Service Info

Renault** - 228 0073 11 - 280/280 TGU6

New design / Neues Design / Nouvelle conception / Nuevo diseño / Nuovo disegno

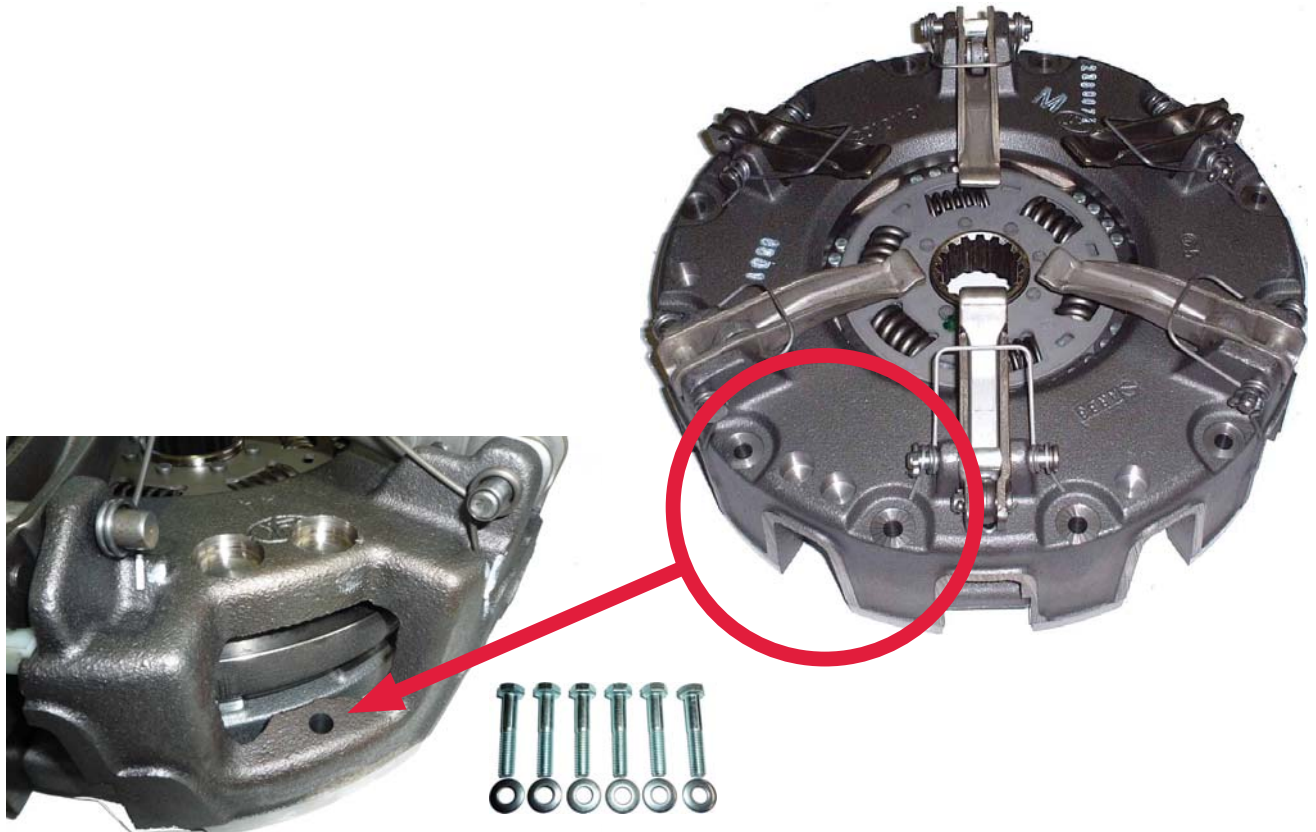
This new design utilises the latest clutch technology, using a vented housing for improved cooling and heat dispersal.

**Fully interchangeable with existing clutches with no modifications required to vehicle or flywheel.
New fixation bolt set 6 x M8 x 1.25 x 50mm is supplied with new designs to accommodate the lower housing.**
